Service Bulletin #67

Subject: Snowthrower chute pop rivet replacement kit #27883 for 1973 models 5 thru 8 HP friction drive units.

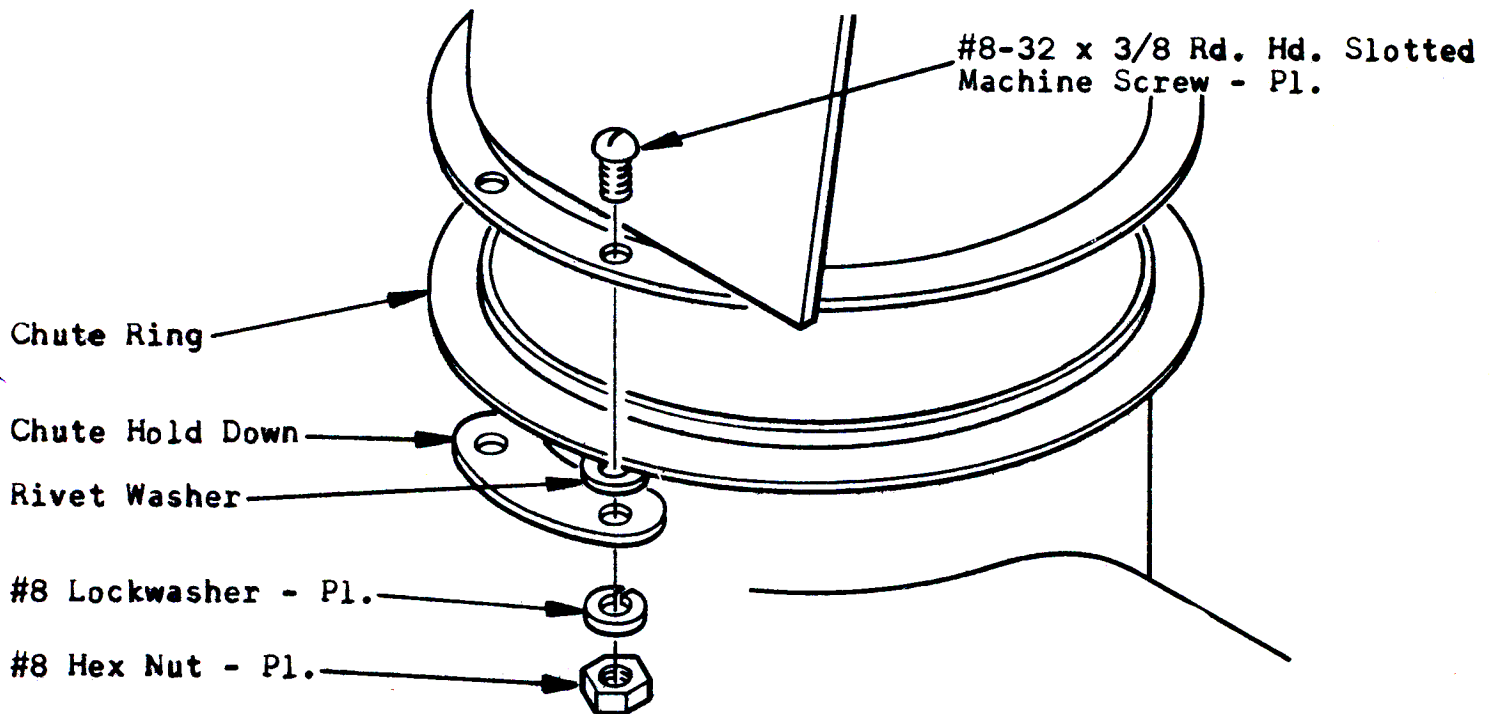
Aluminum-pop rivets failures on the snowthrower chute and gear assembly have been reported. This problem can be corrected by ordering number 27883 field kit, or if hold down clips are not lost, replace rivet with standard hardware listed below. The complete repair is approximately a 15 minute job and may be handled under warranty. File one claim for all repairs, but list individual unit serial numbers. The repair is simple, using common tools; many of your customers could handle this repair themselves. This would expedite time and eliminate the inconvenience of bringing the unit into your shop.

Replace all 6 pop rivets in the following manner. To remove rivets from chute assembly, use a 5/32 drill to drill out rivets or chisel heads of pop rivets off. Insert #8-32 x 3/8 Rd. Hd. Machine Screw through top of holes in chute assembly. Attach 24284 chute hold down and fasten with spring lockwasher and tighten nut securely.

If the chute binds when screws are tightened, remove one chute hold down and insert two rivet washers between chute hold down and chute ring. Repeat this operation with the other chute hold downs until chute moves freely.
